COMBINED BASIC AND DETAILED DEVELOPMENT PLAN - The applicant, BLAZE PROPERTIES, is requesting approval of a Combined Basic and Detailed Development Plan for a Chipotle Mexican Grill. Property is located at Brandt Pike and Miami Valley Way (CBDP 26-11).

Staff Report for Meeting of May 12, 2026

To: Huber Heights City Planning Commission
From: Aaron K. Sorrell, Assistant City Manager
Date: May 6, 2026
Subject: CBDP 26-11 (Chipotle Brandt Pike)
Brandt Pike and Miami Valley Way

1 SITE PLAN
1.0 SCALE: 1/32" = 1'-0"

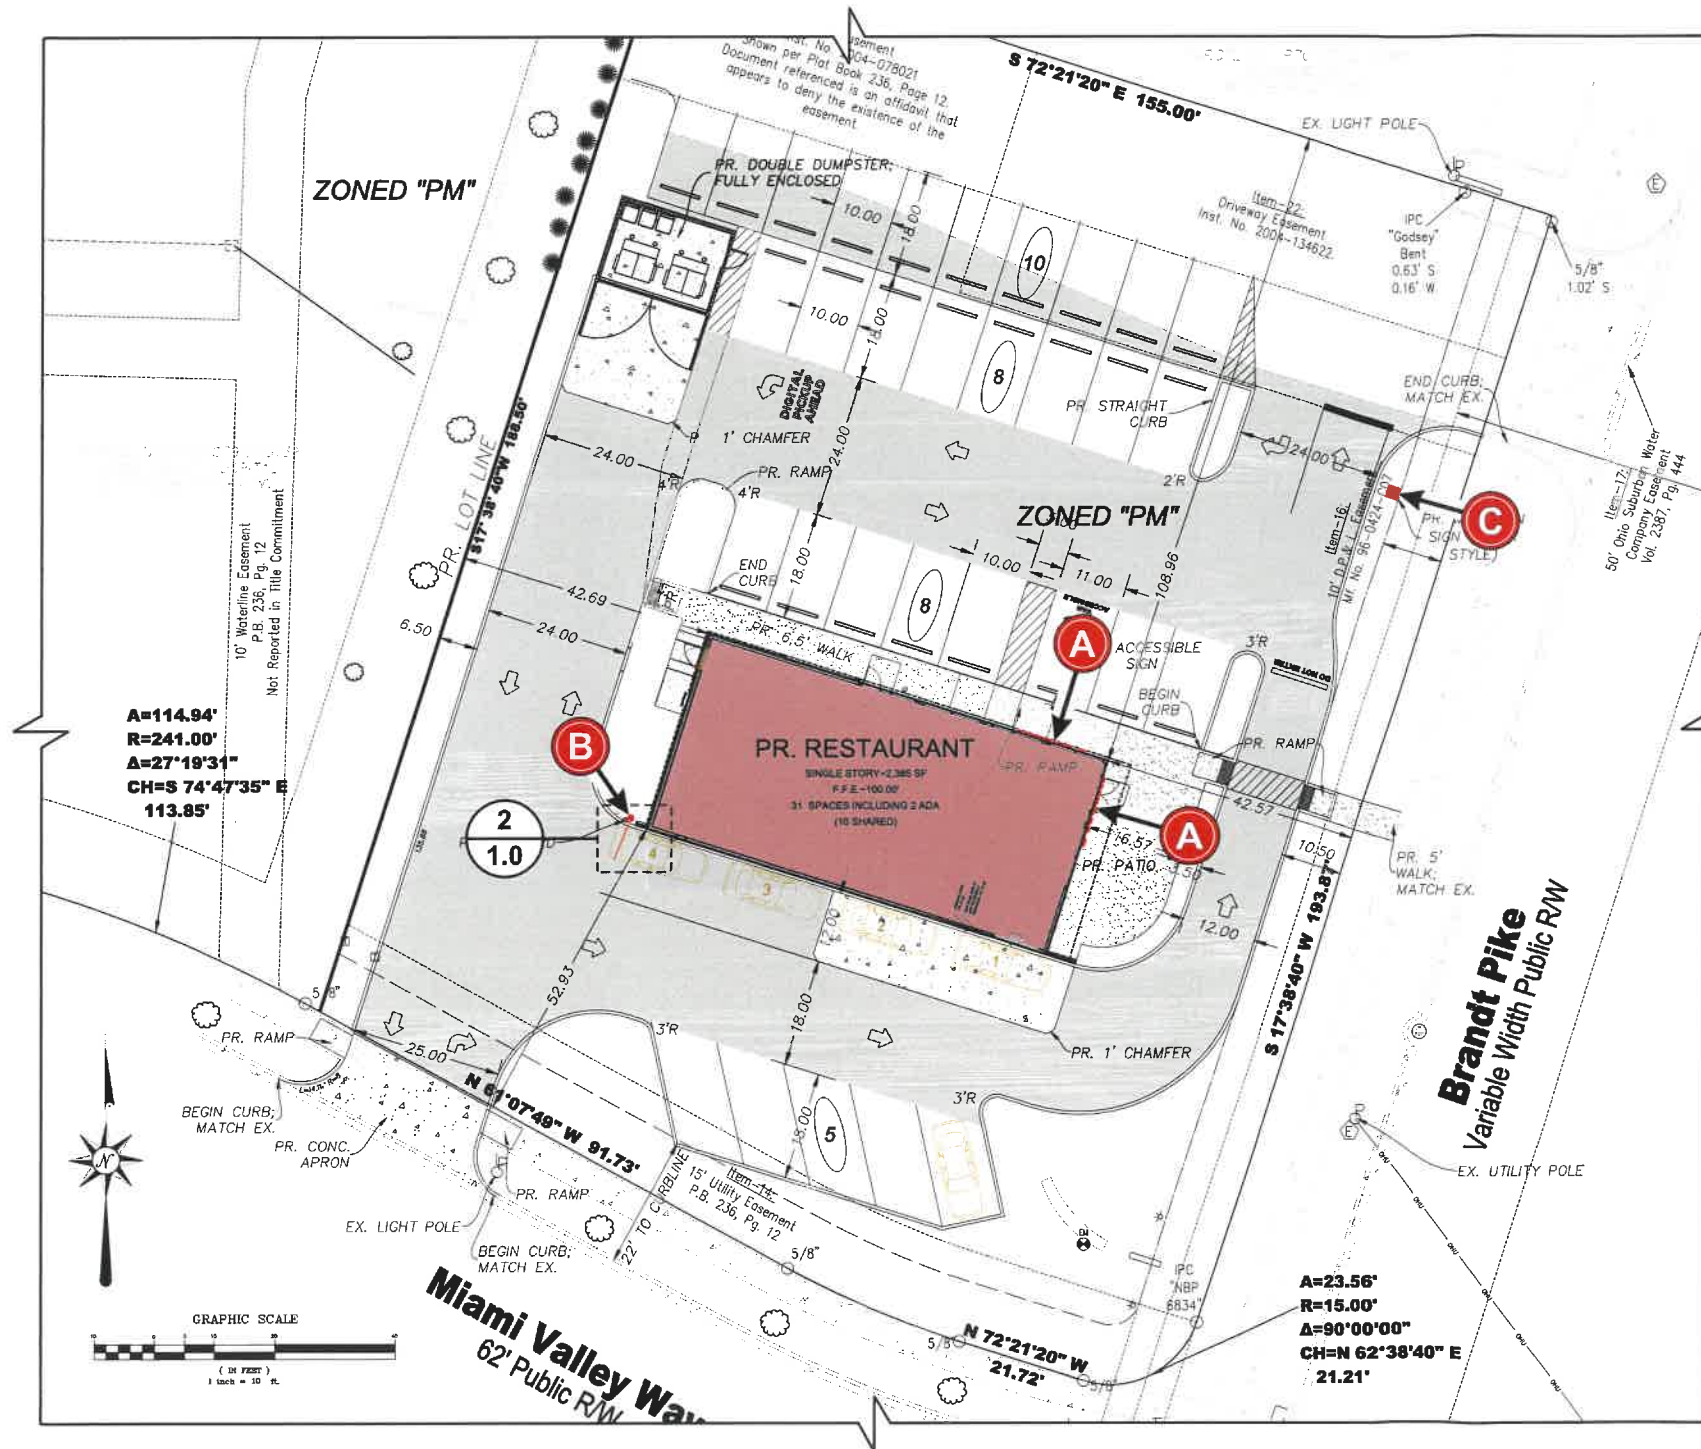
revise wall sign placement

1 WEST ELEVATION
2.0 SCALE: 1/8"= 1'-0"

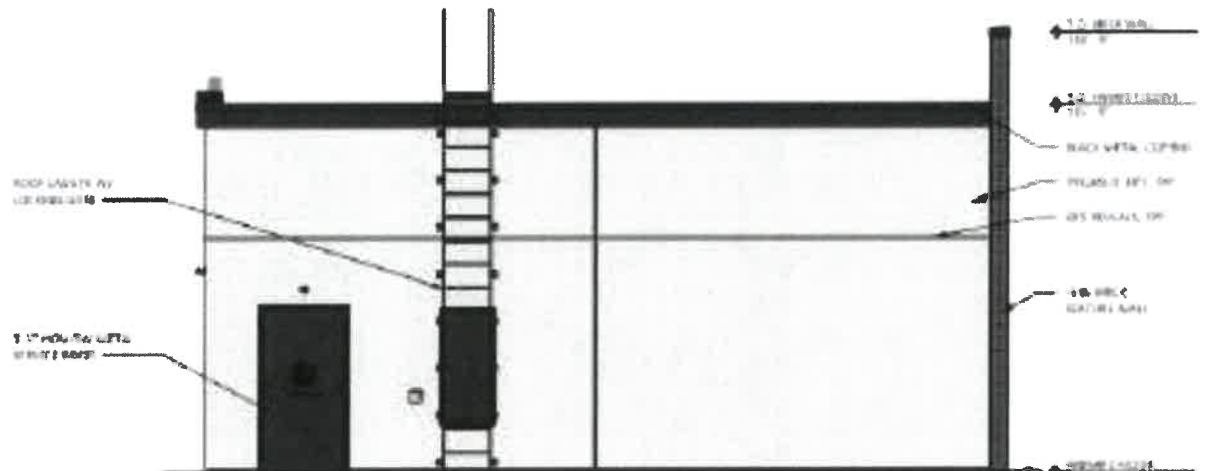
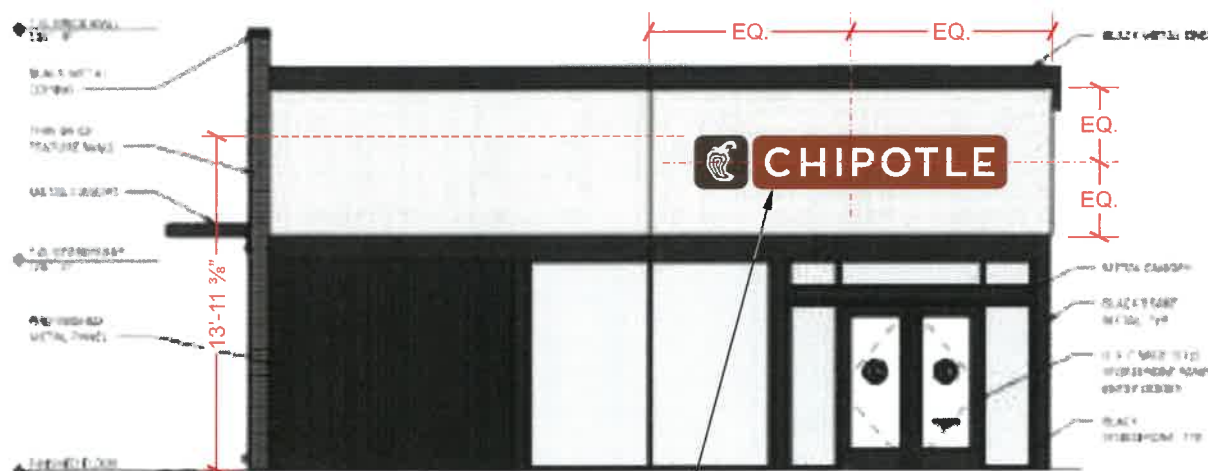
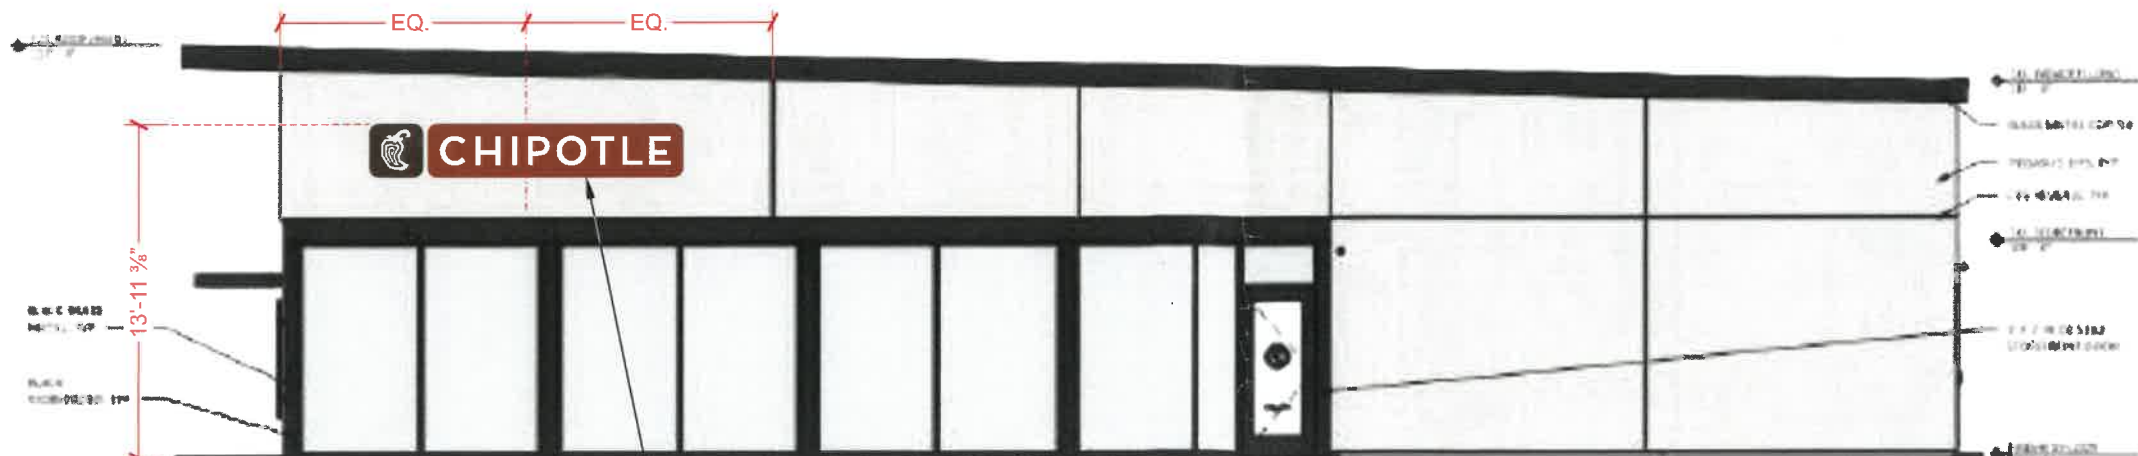
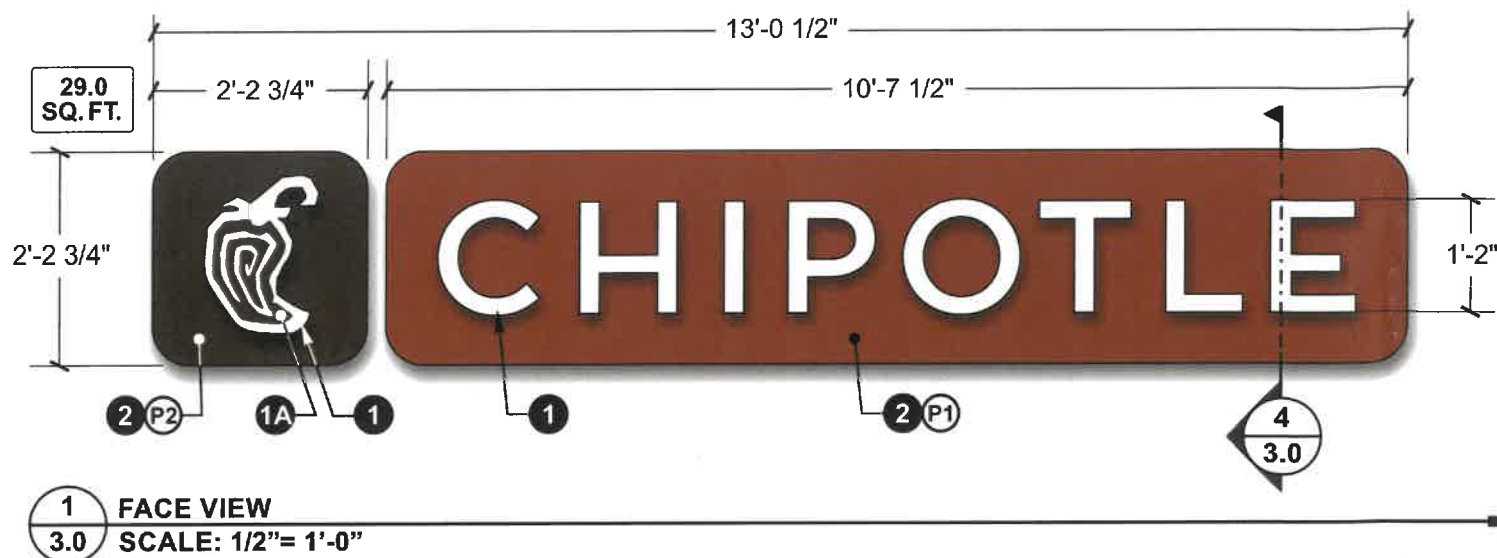
revise placement
